APPLICATION FOR APPROVAL OF CONSTRUCTION CHANGE DOCUMENT - CCD CATEGORY A

School District/Owner: Davis Joint Unified School District	DSA File #: 57 - 11
Project Name/School: Cesar Chavez Elementary School	DSA App. #: 02 - 114122

APPLICANT		
CCD #: 005	Date Submitted: 9-22-2015	Attached Pages?: <input type="checkbox"/> No <input checked="" type="checkbox"/> Yes (<u>5</u> pages)
Firm Name: HMC Architects		Contact Name: Raija Clar
Email: raija.clar@hmcarchitects.com		Phone Number: (916) 325-1100
Address: 2495 Natomas Park Drive, Studio 655		
City: Sacramento	State: CA	Zip: 95833
<input type="checkbox"/> A DSA 301-N, DSA 301-P, or 90-Day Letter has been issued for this project.

<p>CHECK THIS BOX: <input type="checkbox"/> To confirm that all CCD drawings and calculations have been stamped and signed by the Responsible Design Professional.</p> <p>Brief description of construction change (attach additional sheets if needed): Per field trip note CS-01 by Lucinda Johnson existing toilet rooms to be revised to be accessible and existing roof eave to be revised to allow accessible path of travel.</p> <p>List of DSA approved drawings affected by this CCD: A1.1</p>

FLOOR PLAN - BLDG D 2
1/4" = 1'-0"

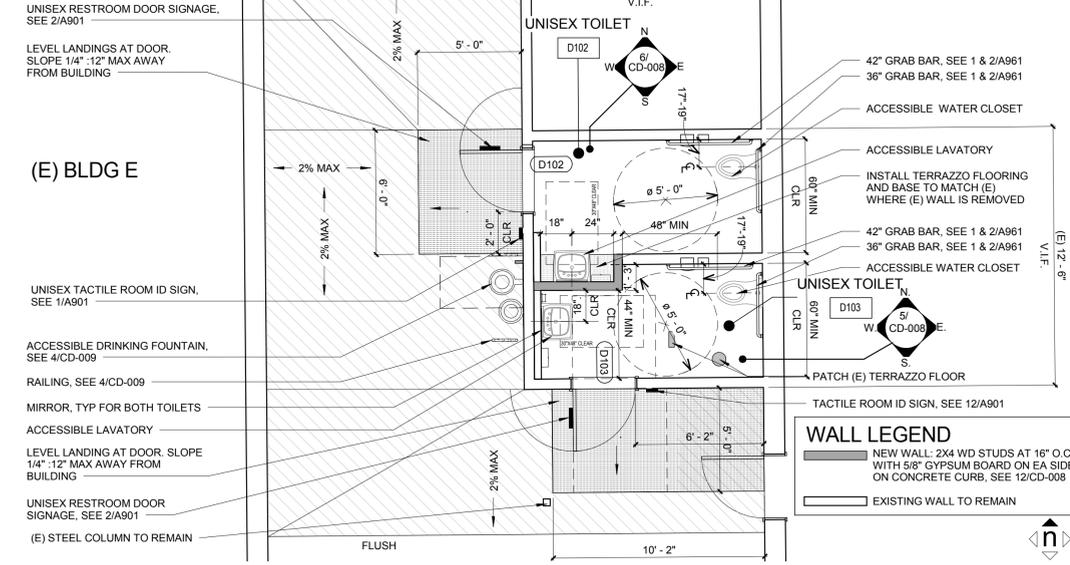
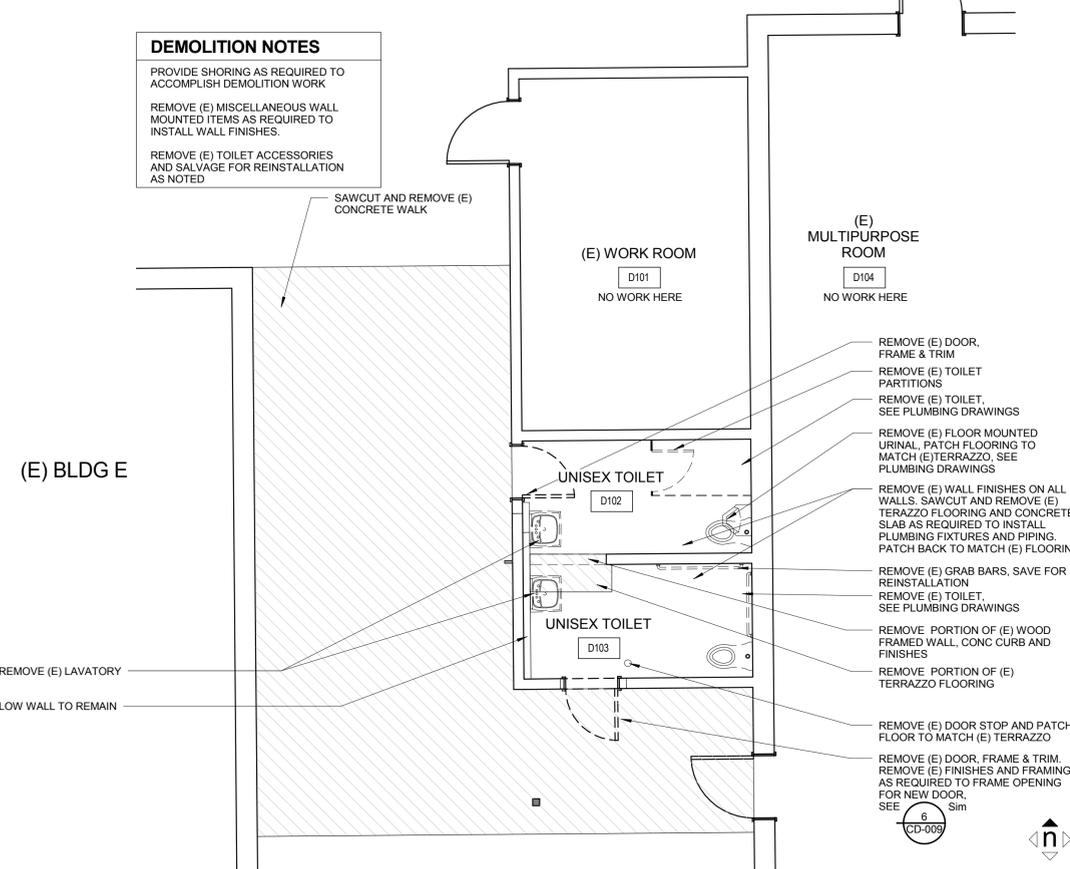
4" THICK CONC. WALK W/ 1.4 X 1.4, 6X6 WWF AT MID DEPTH ON COMPACTED SUB GRADE. MAX 2% SLOPE IN ANY DIRECTION. SLOPE TO DRAIN AWAY FROM BUILDINGS. MAKE FLUSH AT DOOR THRESHOLDS & WITH EXISTING CONC. WALK

DEMOLITION PLUMBING FLOOR PLAN - BLDG D

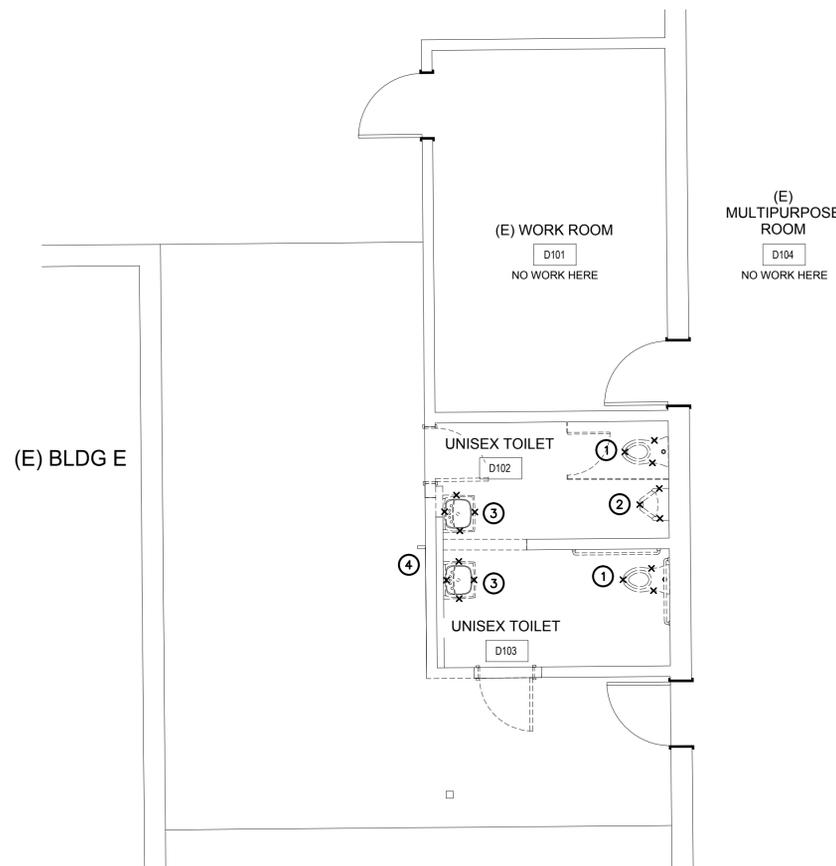
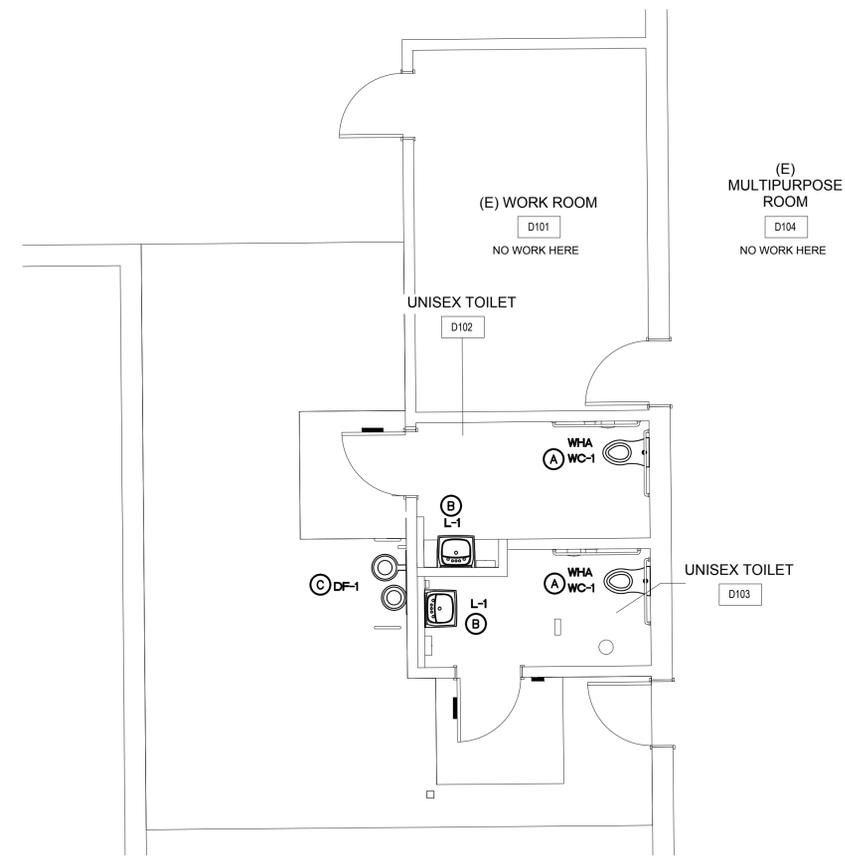
- ① EXISTING WATER CLOSET TO BE REMOVED AND REPLACED WITH NEW. ADJUST EXISTING PIPING TO ACCOMMODATE NEW ROUGH-IN REQUIREMENTS OF REPLACEMENT WATER CLOSET.
- ② EXISTING URINAL TO BE REMOVED. CAP UNUSED PIPING ABOVE, BELOW OR BEHIND ARCHITECTURAL FINISHES.
- ③ EXISTING LAVATORY TO BE REMOVED AND REPLACED WITH NEW. ADJUST EXISTING PIPING TO ACCOMMODATE NEW ROUGH-IN REQUIREMENTS OF REPLACEMENT LAVATORY.
- ④ EXISTING DRINKING FOUNTAIN TO BE REMOVED AND REPLACED WITH NEW. ADJUST EXISTING PIPING TO ACCOMMODATE NEW ROUGH-IN REQUIREMENTS OF REPLACEMENT DRINK FOUNTAIN.
(E) DRINKING FOUNTAIN HAS ALREADY BEEN REMOVED, ONLY PIPING IS LEFT EXPOSED.

- Ⓐ NEW WATER CLOSET TO BE CONNECTED TO EXISTING PIPING ADJUSTED TO NEW ROUGH-IN LOCATION.
- Ⓑ NEW LAVATORY TO BE CONNECTED TO EXISTING PIPING ADJUSTED TO NEW ROUGH-IN LOCATION.
- Ⓒ NEW DRINKING FOUNTAIN TO BE CONNECTED TO EXISTING PIPING ADJUSTED TO NEW ROUGH-IN LOCATION.
